**HODGESVILLE PUBLIC SERVICE DISTRICT  
UPSHUR COUNTY, WEST VIRGINIA**

**MURPHY STATION ROAD EMERGENCY WATERLINE EXTENSION PROJECT**

**ADDENDUM #1**

**SEPTEMBER 1, 2023**

PHASE No.
CONTRACT No.
PROJECT No.
<b>T10-11067</b>

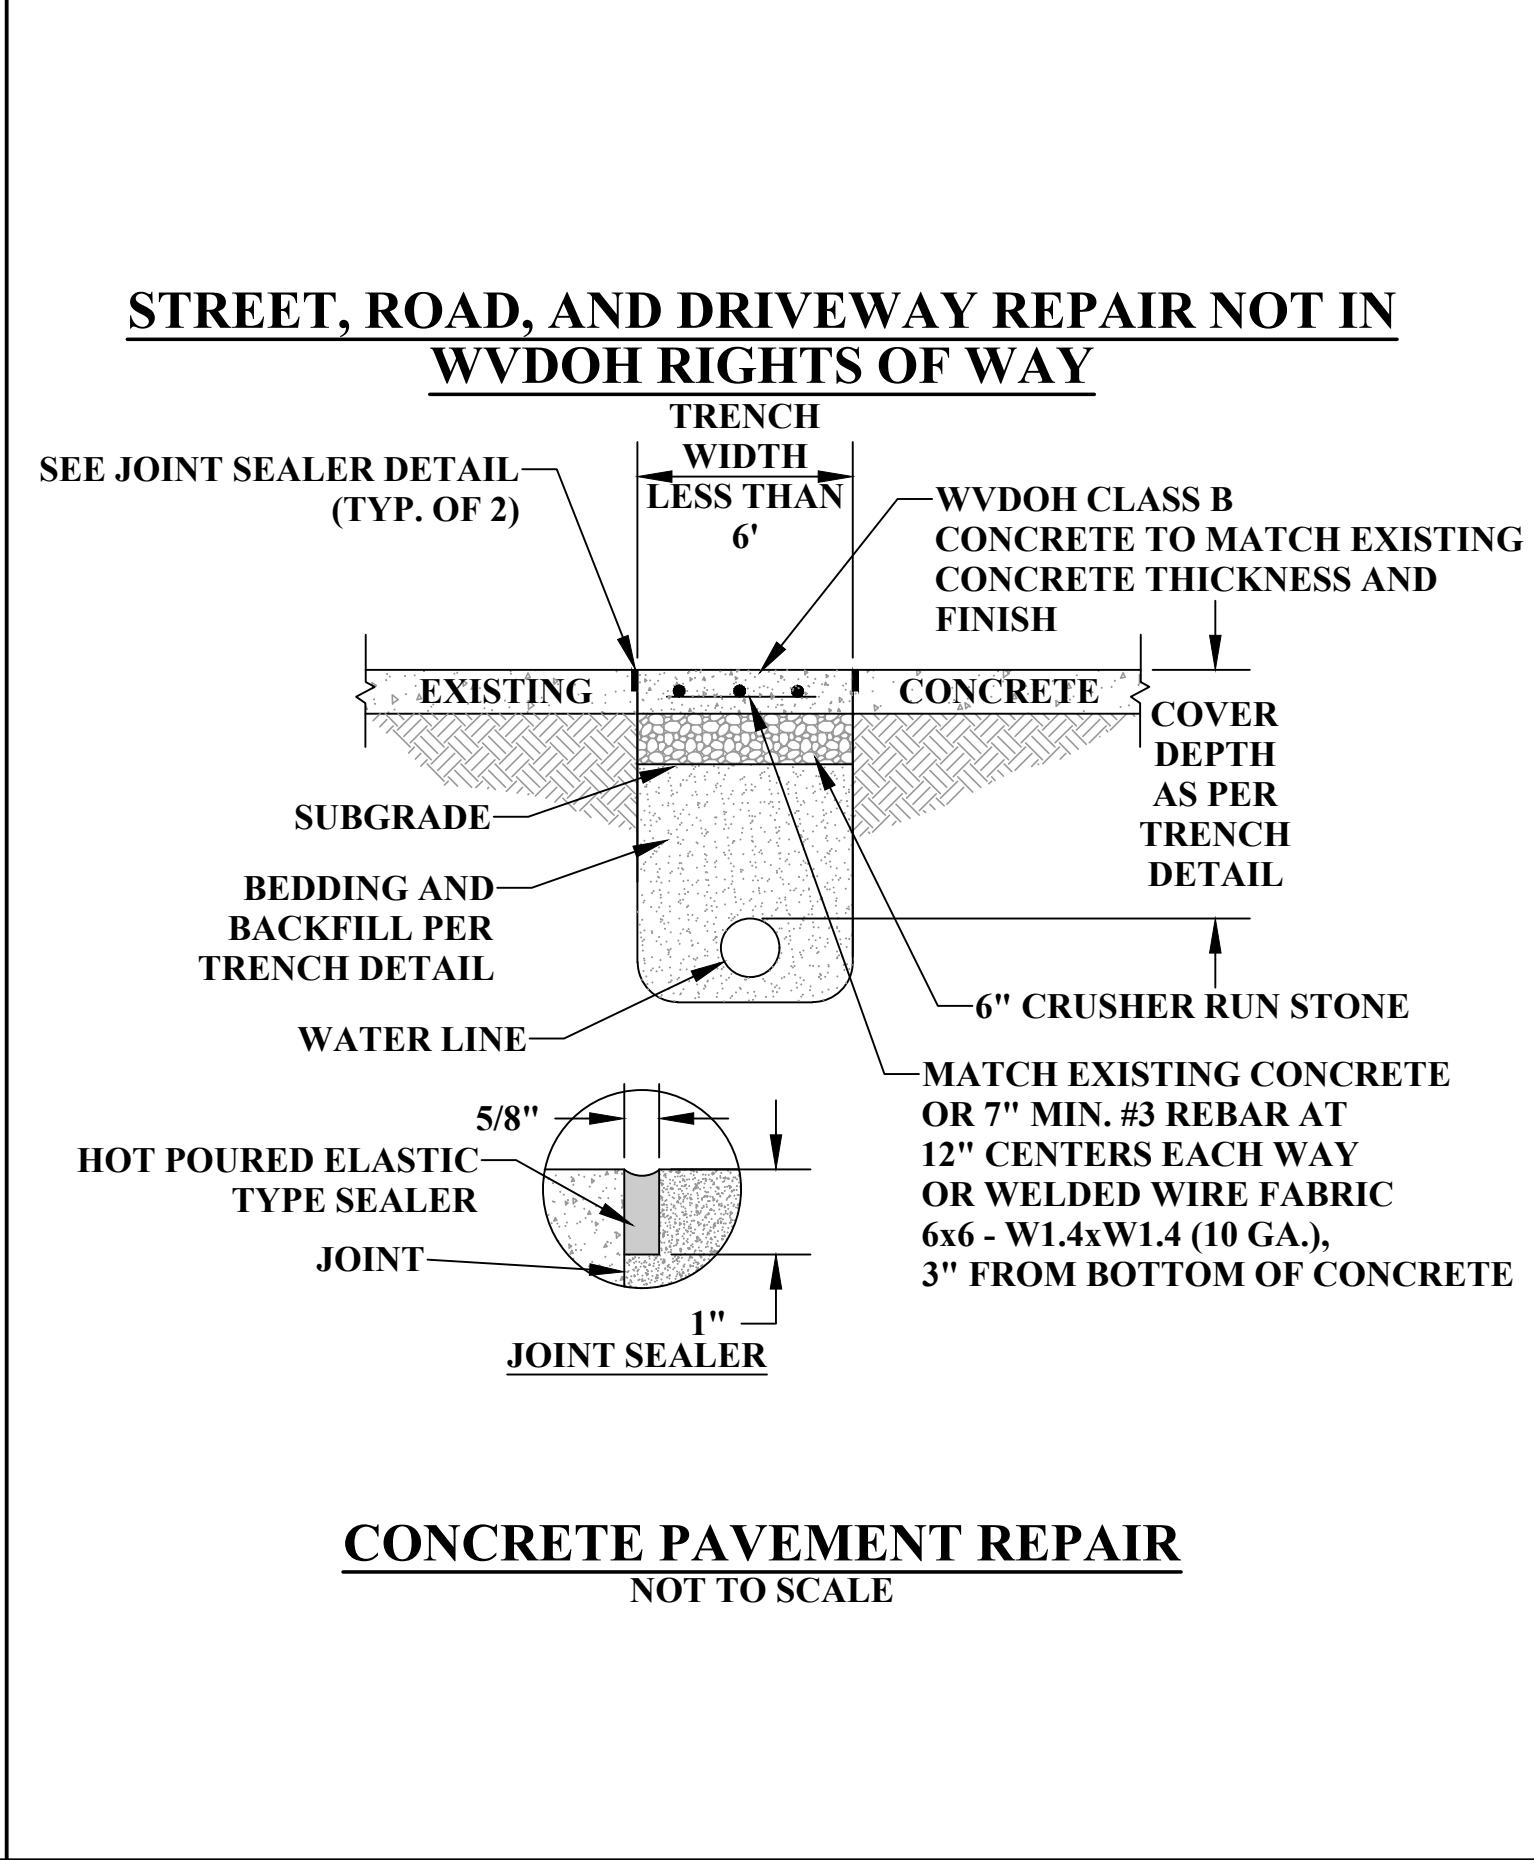
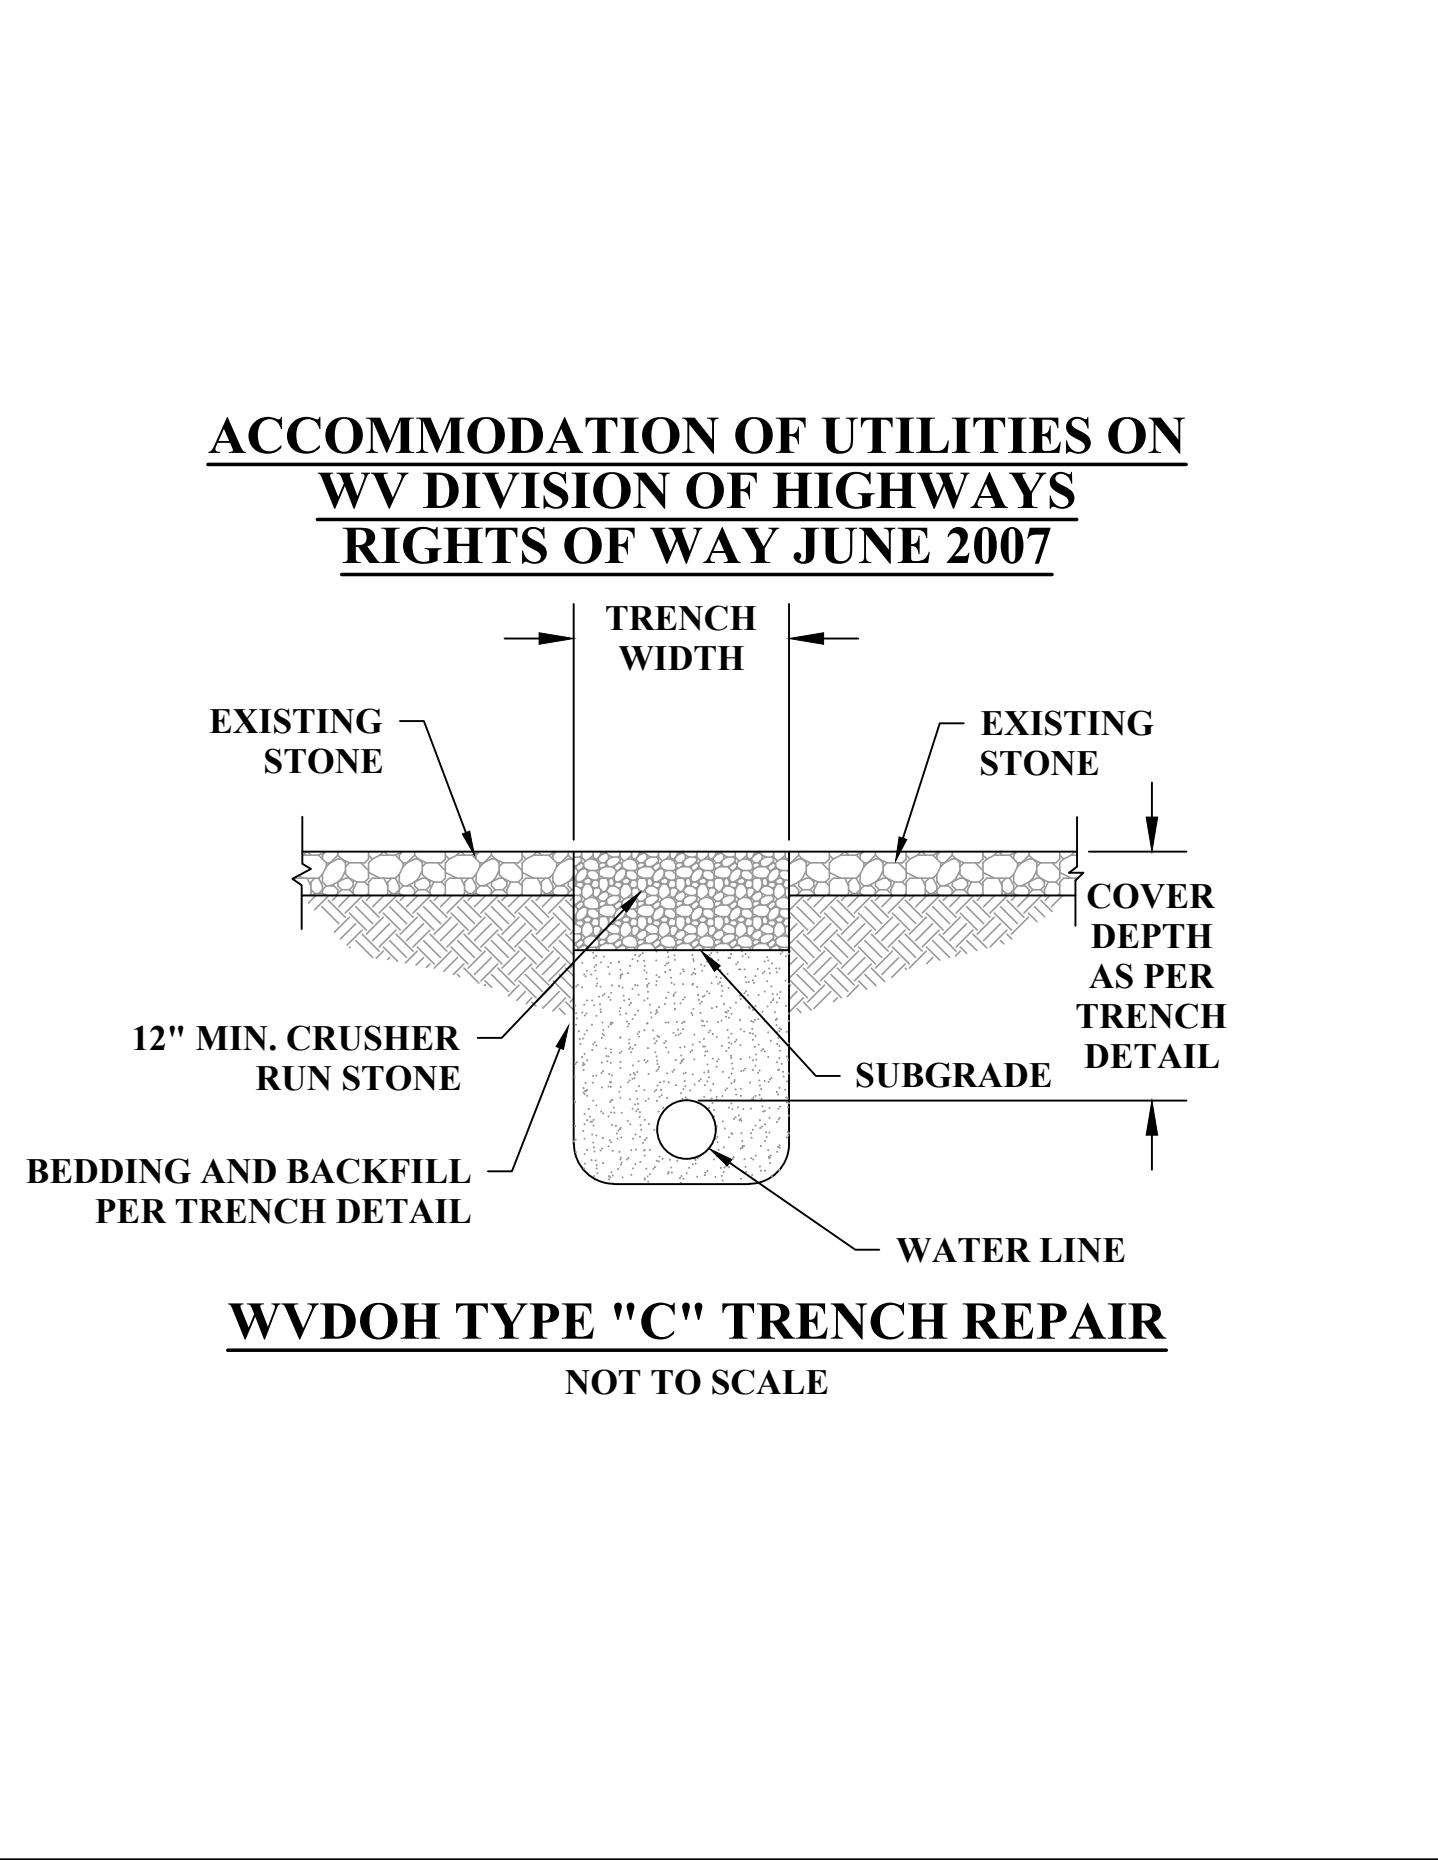
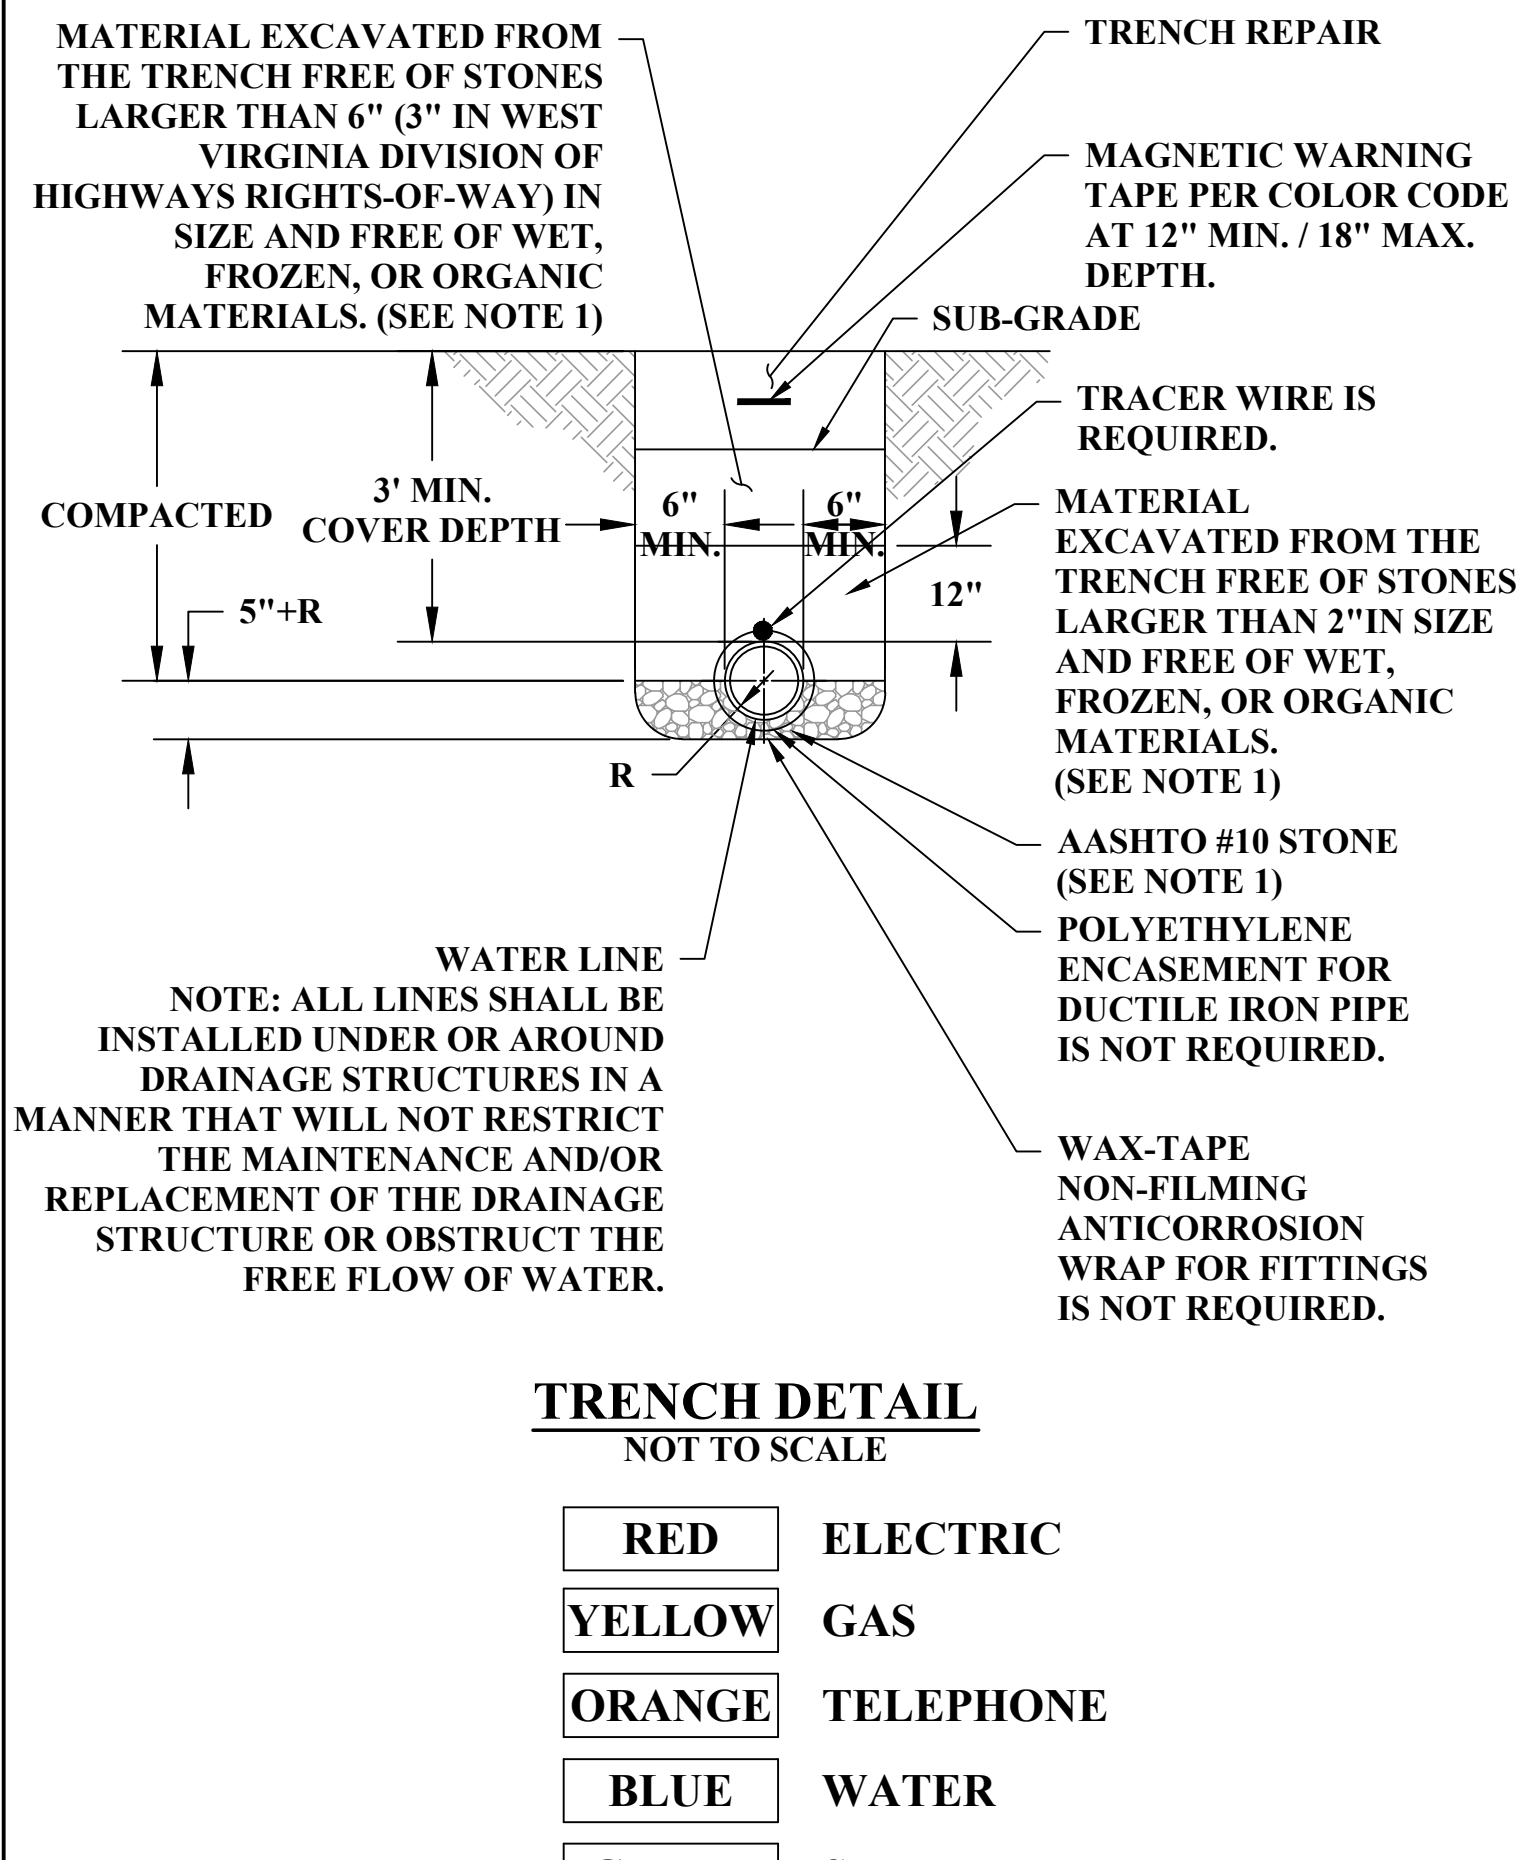
Can the engineer provide a waterline trench detail?

Yes, the trench detail has been added to sheet D1 under "Trench Detail." The revised Typical Water Detail Sheet #D1 is included with this Addendum.
